Staff Report

To: BOZAR
From: Jessie Earley, Town Planner III
Meeting Date: BOZAR, February 25, 2025
RE: Liebl (226 Sopris Avenue), Final Review

PROJECT TITLE: Liebl (226 Sopris Avenue)

2/10/2025 DRC and 2/25/2025 BOZAR: revised south rendering

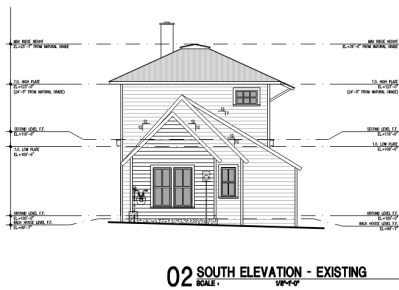
GL	Staff Analysis	DRC Recommendation
3.17 Additions to historic buildings	Primary: The addition to the primary building fills in a small area on the southeast corner. A 3D rendering showing the existing and proposed area would be helpful to show the change. The proposed renderings have been provided. Accessory: The addition to the accessory building steps down from the main ridge and also from the north and south. A change in material would be encouraged.	Support

3.18 a Stepping down additions	Primary: The addition will continue the roof pitch that is existing in the southwest corner of the building 12:12. Accessory: The addition on the west steps down 4'3" from the main ridge. Discussion is encouraged to determine if the addition is subordinate.	Support

2/10 DRC and 2/25 BOZAR: Revised Site Plan

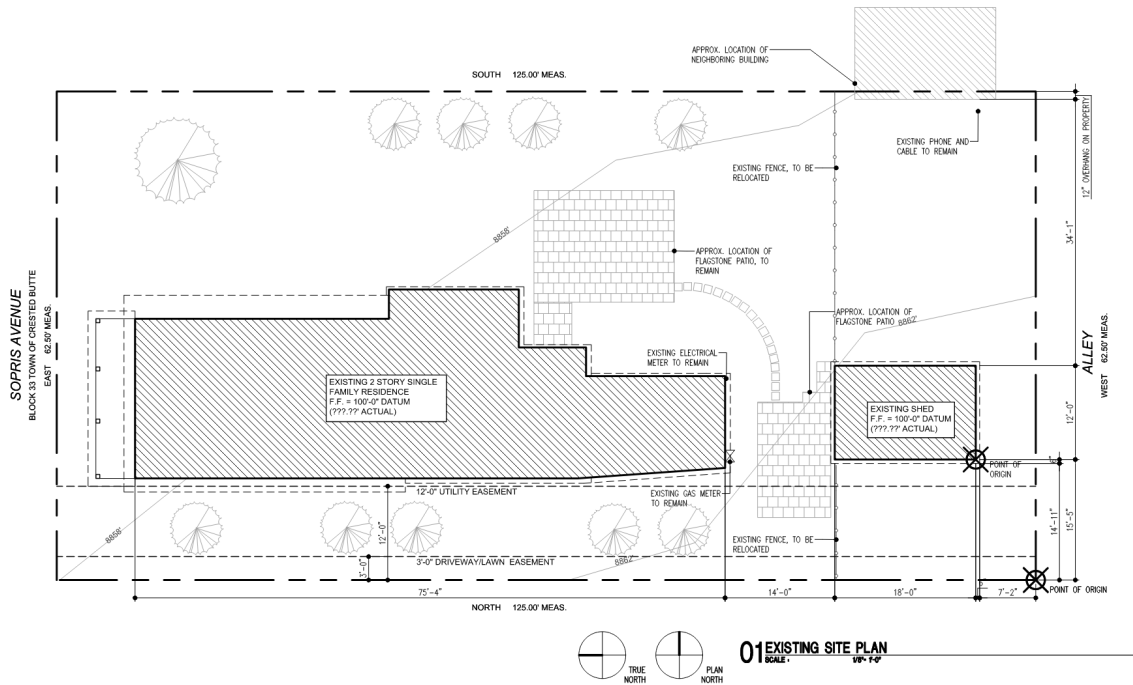
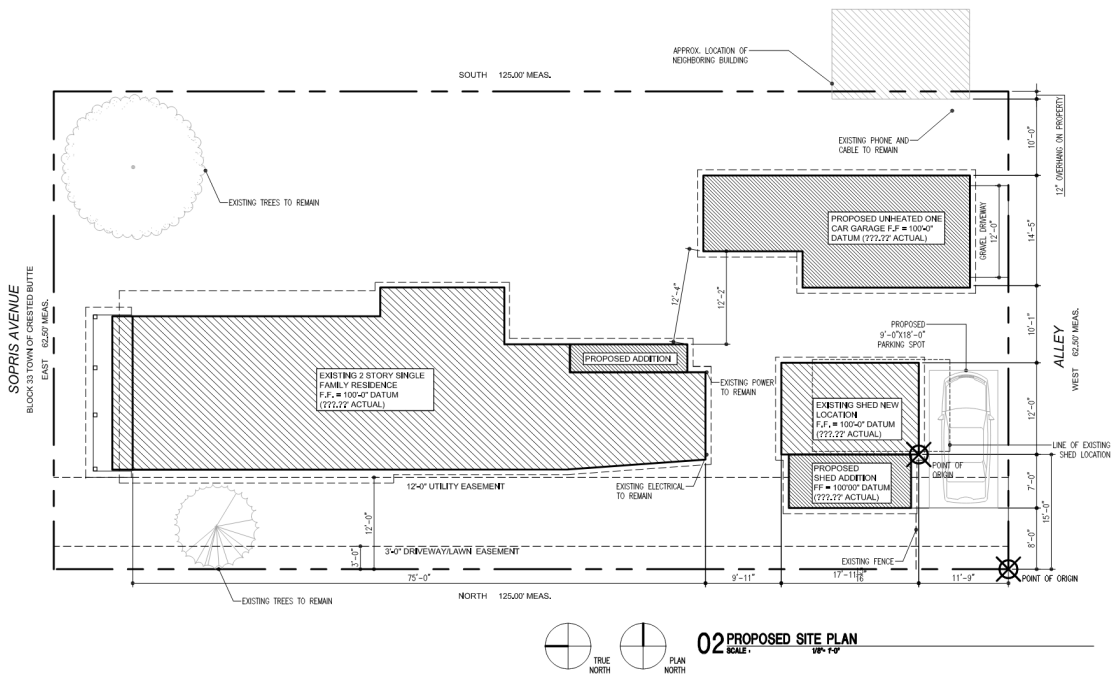
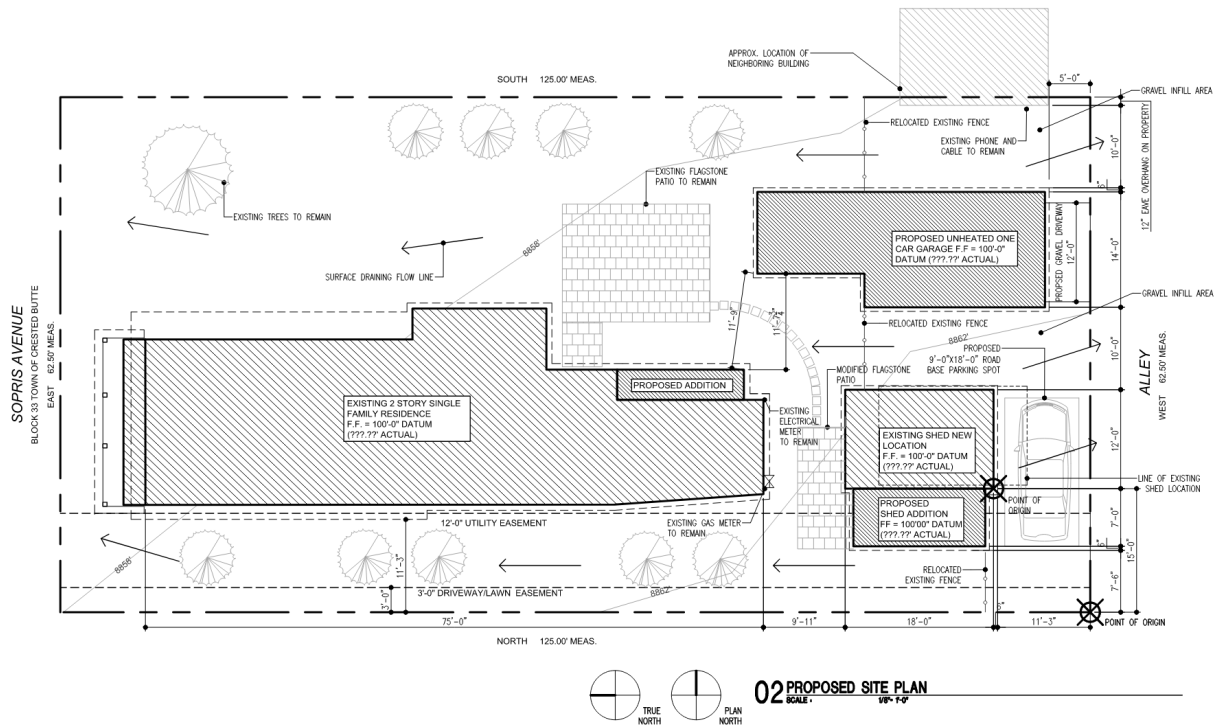
GL	Staff Analysis	DRC Recommendation
Topography	Topography is not included, but should be. This information is not anticipated to impact FAR or height requirement.	Add information to the plans
2.8 Drainage	Drainage arrows have been shown and show drainage to the north and south to the alley.	Add information to the plans, which has been provided.

Easements	There area existing easements on the west portion of the lot, which includes a 3' driveway easement and 12' utility easement. There is a letter from the property owner to the east expressing support for the addition.	Support with neighbor support.

2.18/3.1 Preservation of existing mature trees	There are existing trees on the north portion of the lot, which are to remain and will not be impacted by the additions. The applicant has added the existing trees to the lot and no trees will be removed. At the 2/10 DRC, there was a suggestion to move the lilac by the electric meter on the south side of the home, as it will be required.	Confirm number of trees, which has been provided.

(2.37-2.40)/ 16-17-40 Exterior Lighting	Existing and proposed lighting has been included. They appear to meet the intents of the requirements. If existing fixtures do not meet requirements, they will be required to be upgraded as part of the work to be done.	Add information to plans, which has been provided.
Solar	NA	NA
Utilities	Existing and proposed wet and dry utilities must be noted on the plan. Rights of way (alley and Sopris Avenue) must be shown to scale on the site plans.	Add information to the plans.

2.7 Snow Storage	Snow storage has been depicted on the plan and corresponds to the areas to be plowed.	Support
2.27 Fences	An existing fence is on the south. Confirmation is needed if there will be a new fence proposed.

South – proposed rear door (primary building)

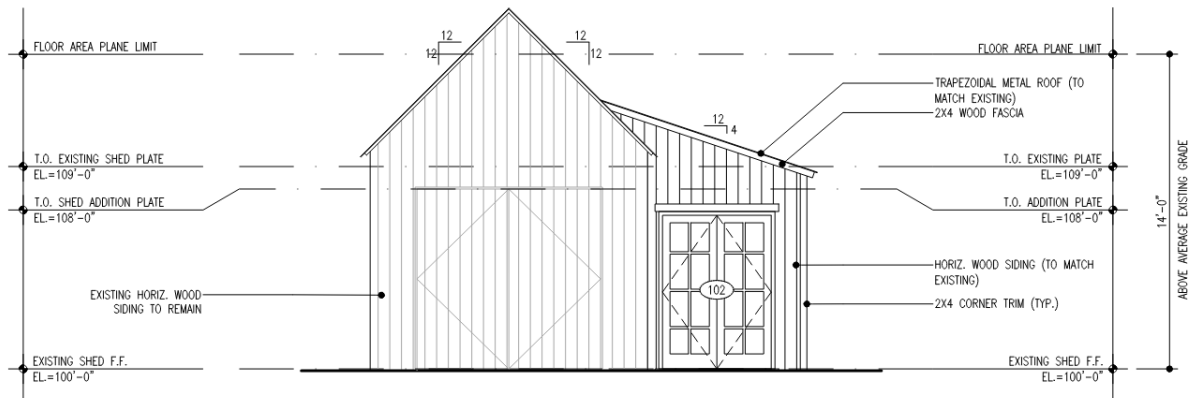
There is a new wood French door with divided lights proposed on the south. The door plan states that this door will be a metal clad door. Confirmation of the door materials is needed.

The garage door (carriage style) existing will be rehabilitated (north). **There is a wood French door proposed on the north elevation with divided lights. The door plan states that this door will be aluminum clad (red), confirmation is needed.**

Proposed Alley view

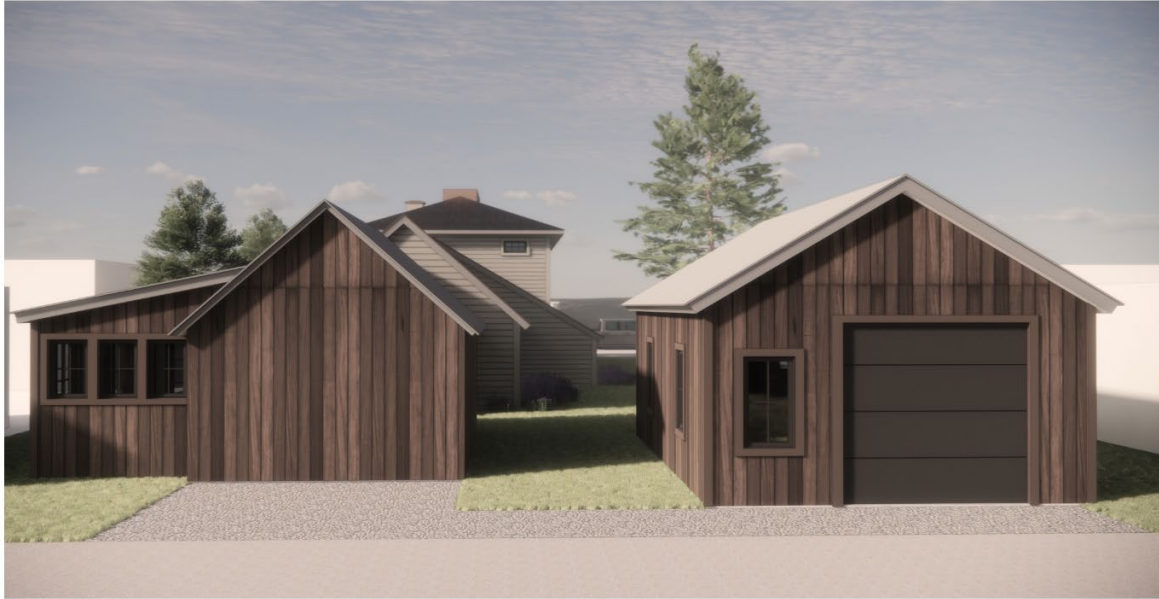
The proposed south cold accessory building is an 22'5"x15'2" gabled building with a smaller gable module to the north 13'x10'5". The accessory has a 8:12 pitch. This must be a cold building due to the size, as proposed.

GL	Staff Analysis	DRC Recommendation
4.84 Smaller in size	The proposed building is smaller in scale than the primary building, as requested by the GL.	Support
4.85/5.94 Rear of the site	The proposed building is located at the rear (south) of the lot. Support.	Support
4.86 Vary appearance	As seen in the 3D models, this building is proposed to mimic the existing historic building to the west. The form of the building is simple and supported. However, the material should be varied from the building to the west.	Support 1/21 DRC: Members voiced that a small distinction would be good, but it should not be too different, as the nature of the buildings are simplicity. A slight differentiation has been provided. 2/10 DRC: Members supported the varied materials as proposed.
4.89 d. porches	NA	NA

2/10 DRC and 2/25 BOZAR: revised flat plan views

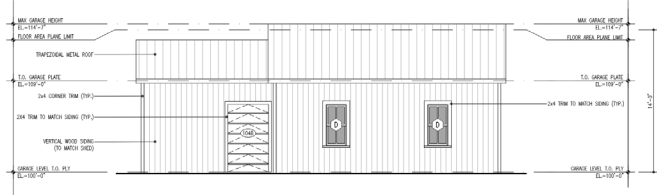
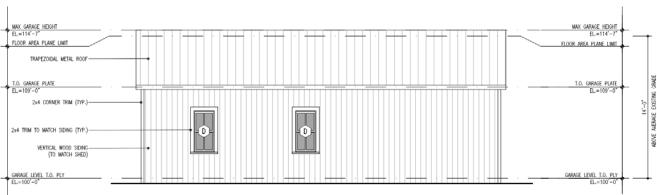
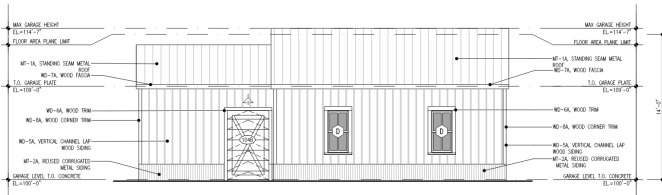
GL	Staff Analysis	DRC Recommendation
4.53; 4.89 AB fenestration	There are two single windows on the north, east and west elevations. The south elevation has one window. There are fewer windows than the primary building. The window to wall ratio for the proposed north elevation is 17.6%. This percentage is more relational to primary building. Staff would suggest reduction in the glazing for this elevation.	Support
4.54 Vertical emphasis	Windows are proposed as two over two awnings with simulated divided lights.	Support
4.56 Window material	Windows are noted as aluminum clad, color confirmation needed. Support.	Support
4.59 Trim	Wood trim 2"x4" (stained brown) is noted. Support	Support

GL	Staff Analysis	DRC Recommendation
4.66 Secondary Doors	There is a ½ light aluminum clad person door on the north, color must be confirmed. Support	Support
4.69, 4.90 Garage doors	There is a garage door proposed on the south elevation and a smaller garage door proposed on the west elevation. Wood veneer was referenced at the DRC meeting. There were traditional barn door details added to both doors.	Support
